ADDENDUM NO. 1

July 20, 2026

This Addendum is hereby made a part of the Contract Documents and modifies and takes precedence over the original Contract Documents dated July 7, 2026.

LEBANON COUNTY MUNICIPAL BUILDING
PHASE II RENOVATIONS
22-036

1.19 A402 ENLARGED PLANS AND INTERIOR ELEVATIONS

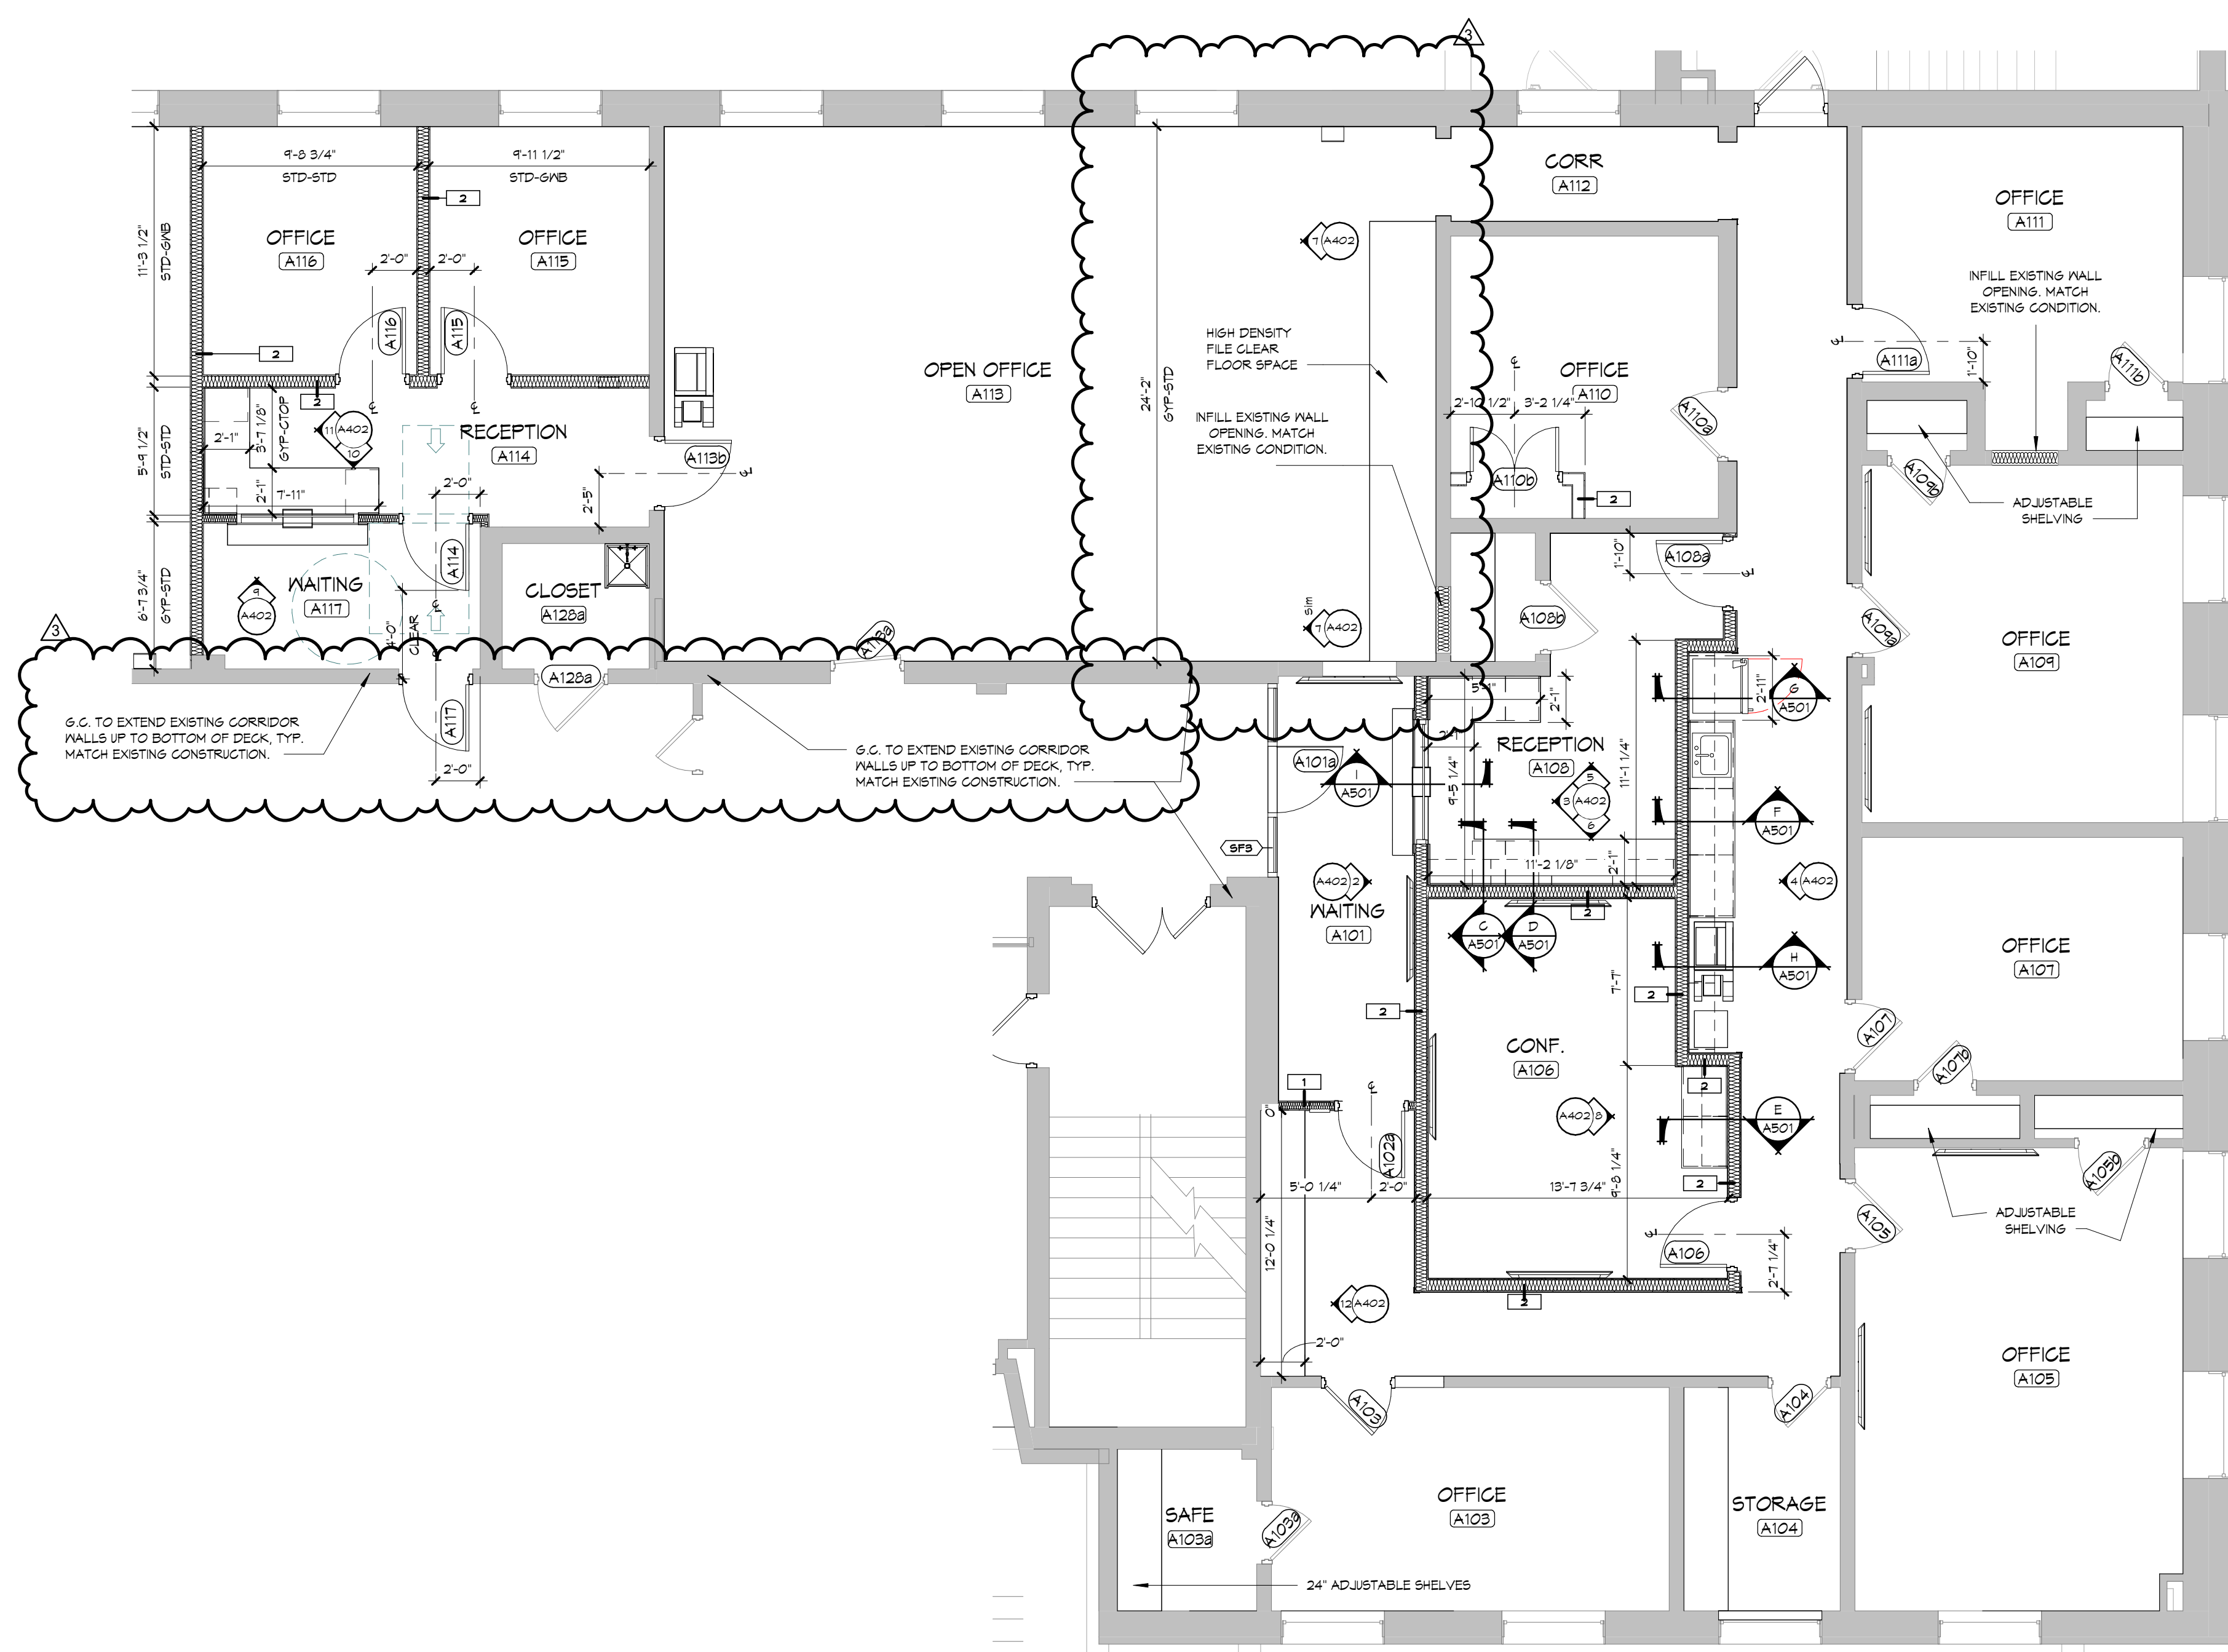
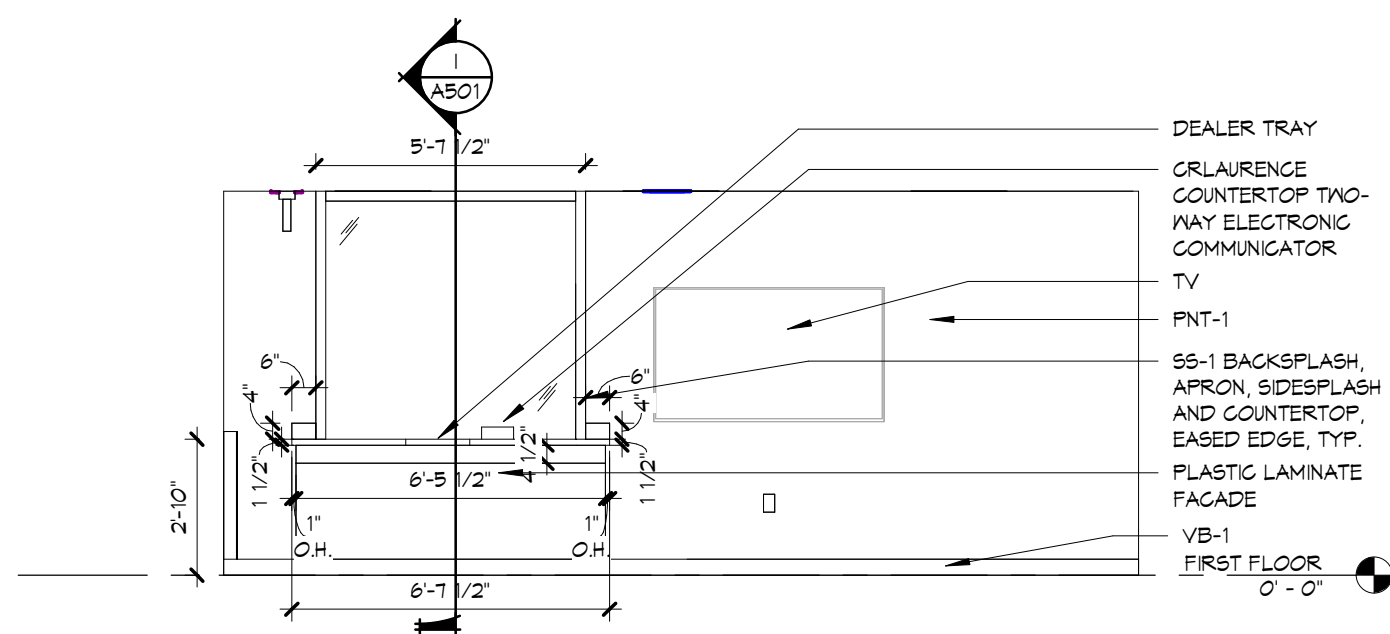
- a. DELETE Wall Shelving in Open Office.
- b. ADD Plan Notes.

1.20 A403 ENLARGED PLANS AND INTERIOR ELEVATIONS

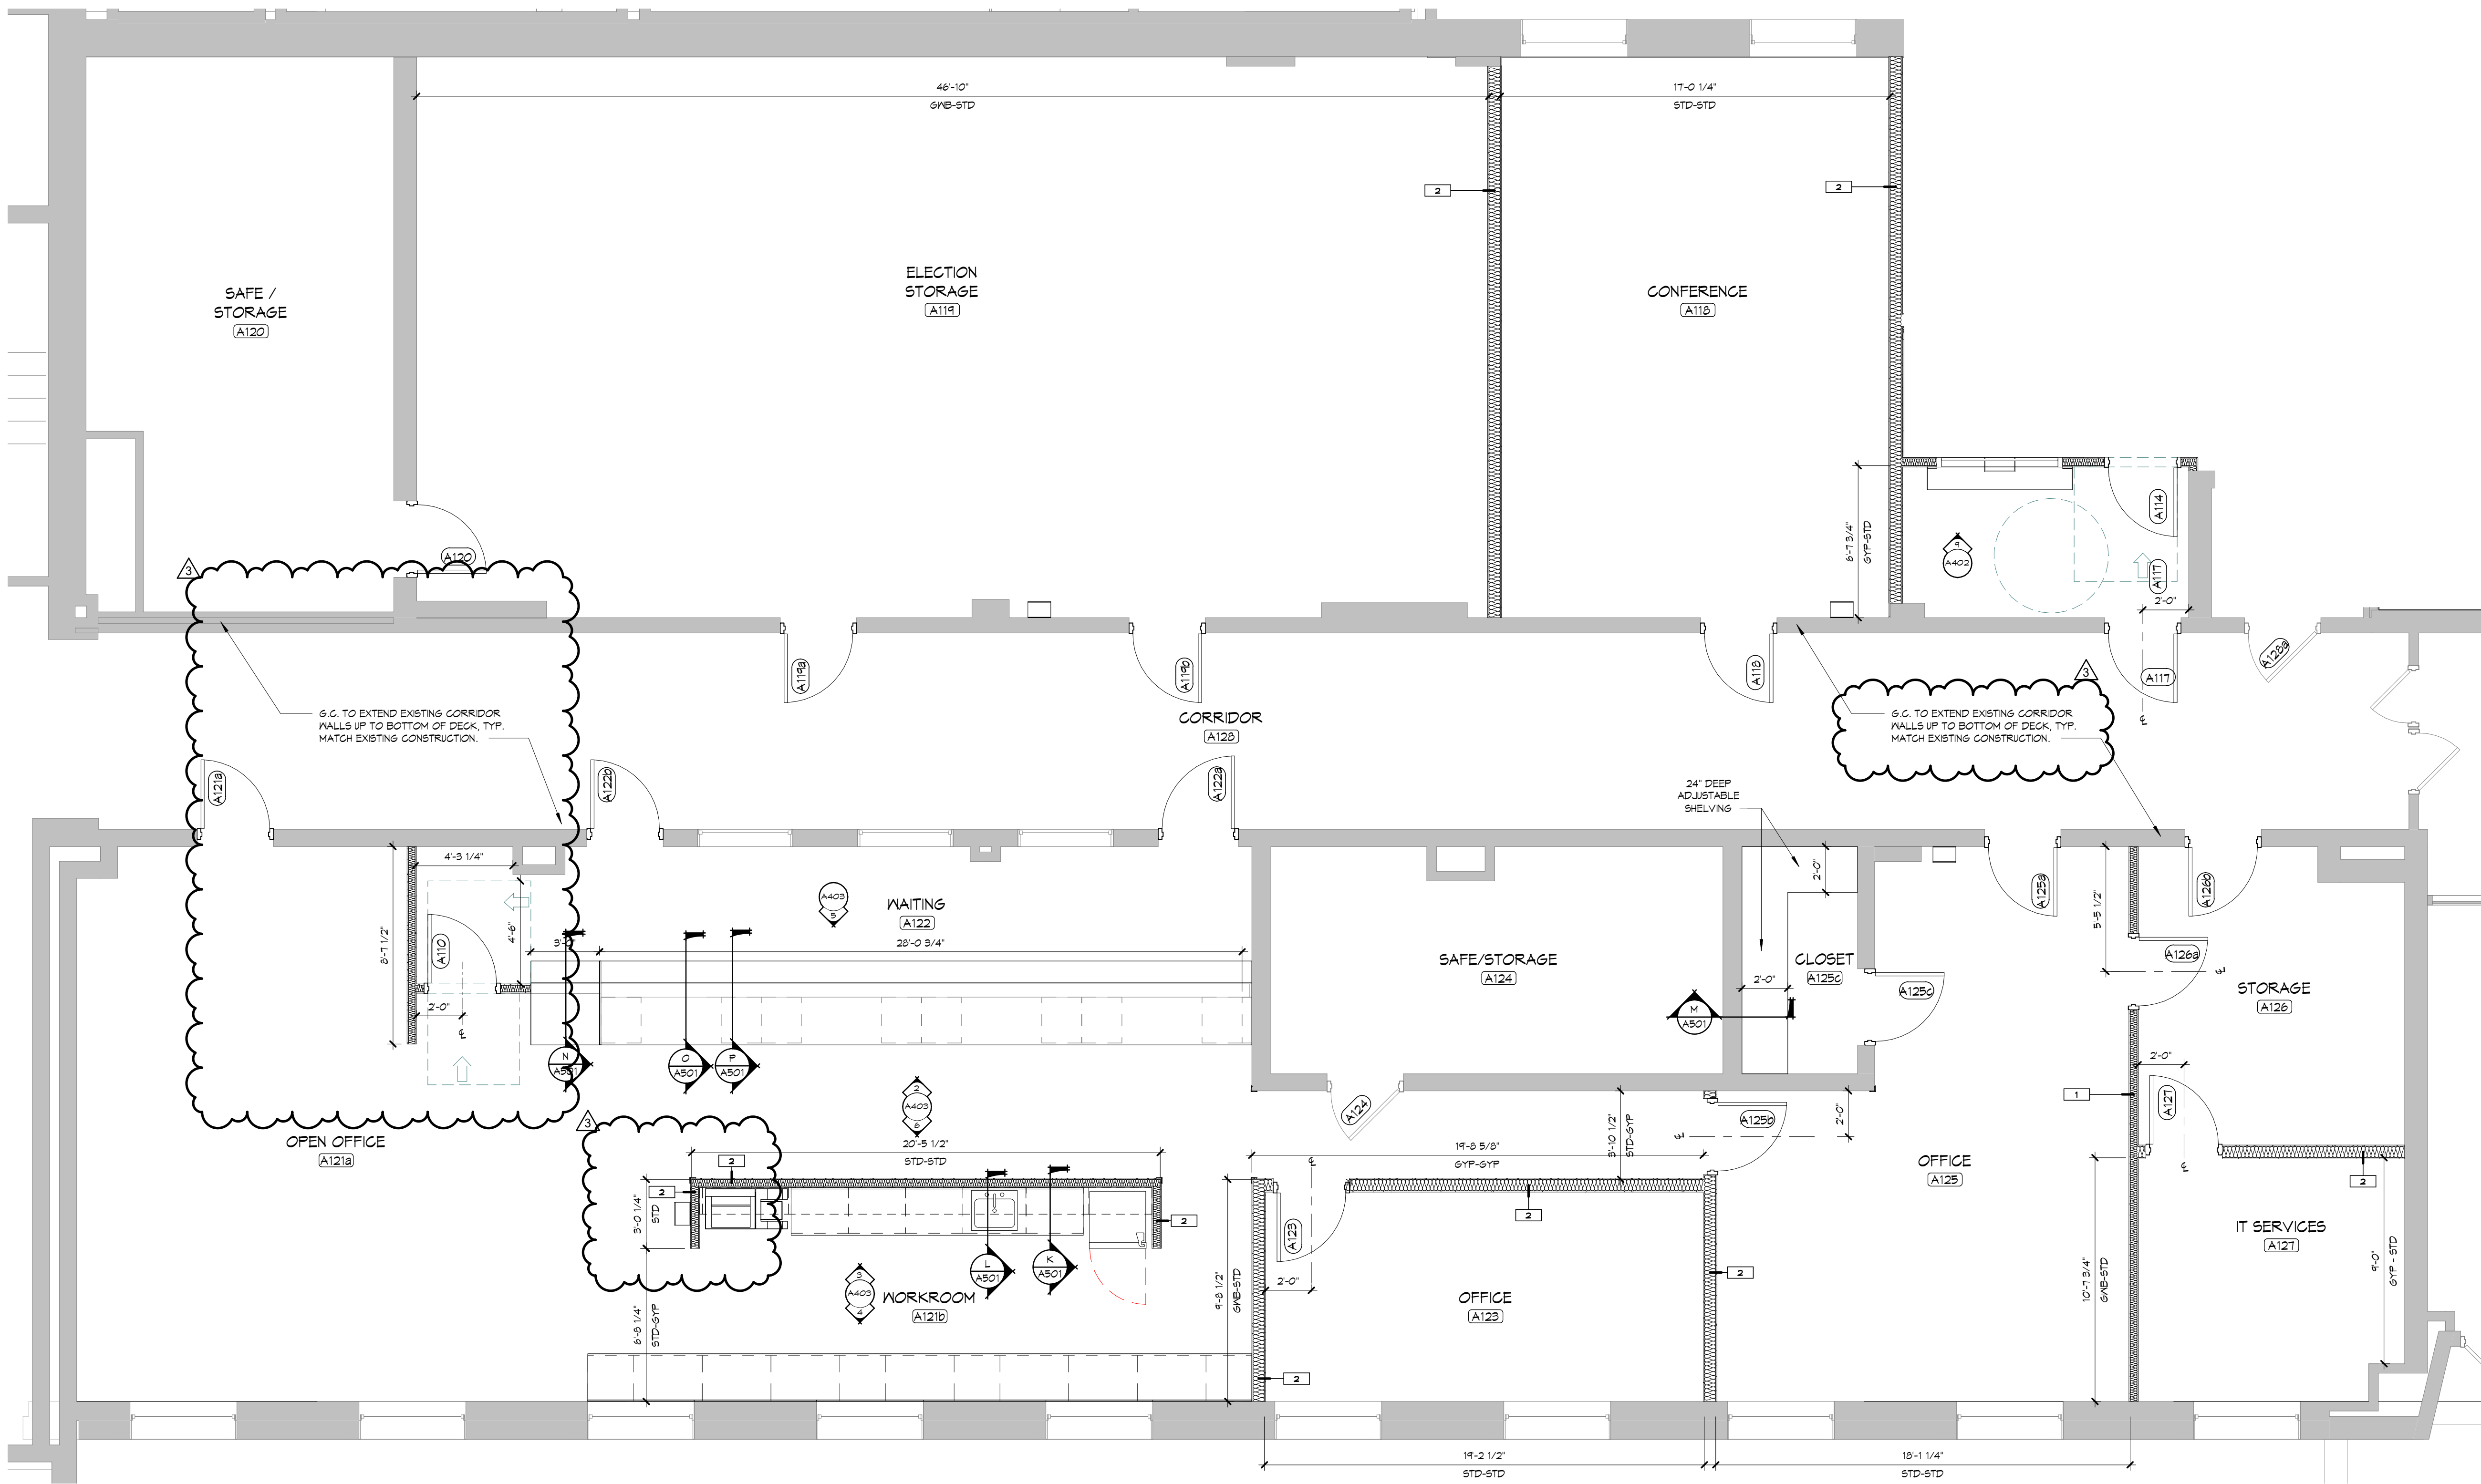
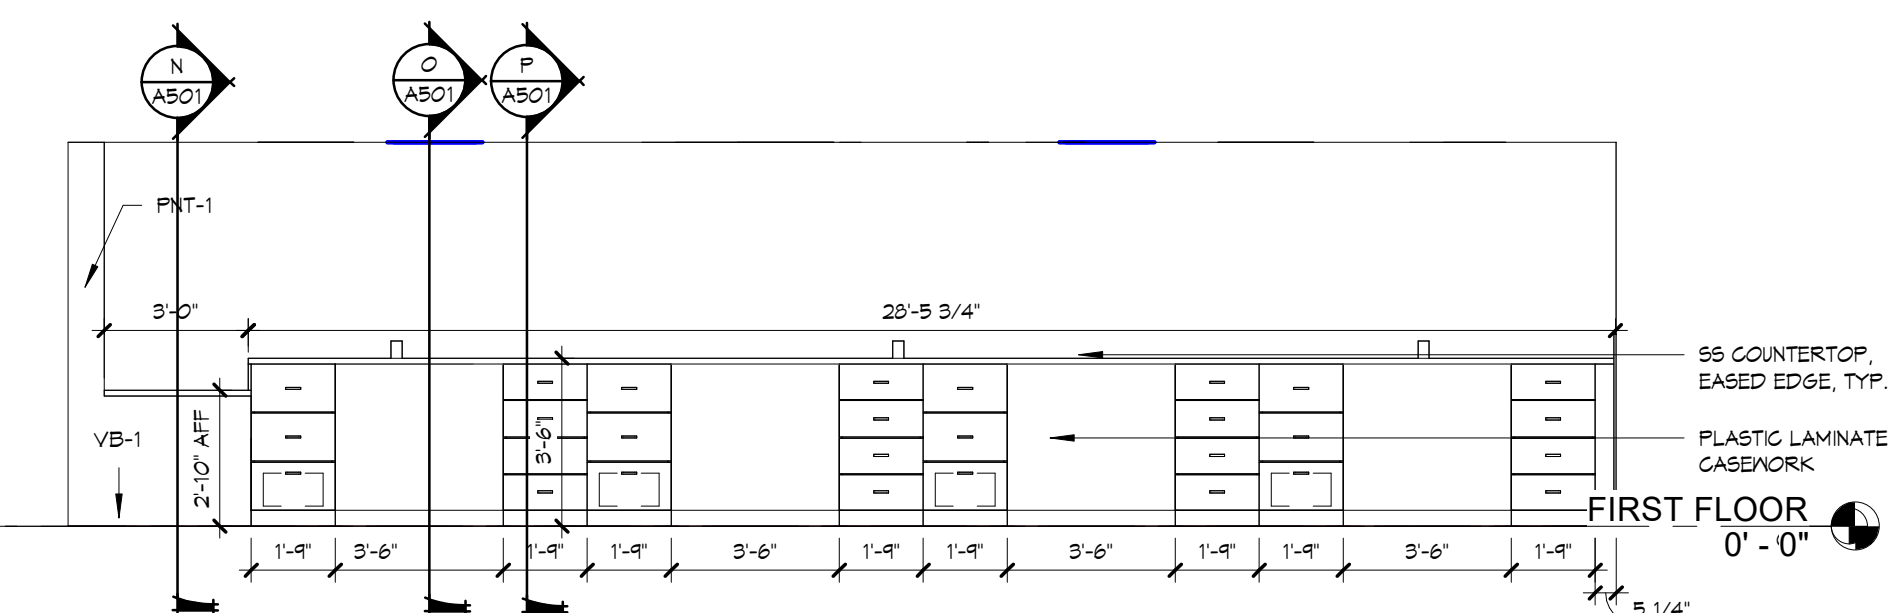
- a. REVISE Open Office Configuration and Entry.
- b. RELOCATE FEC.
- c. ADD Plan Notes.
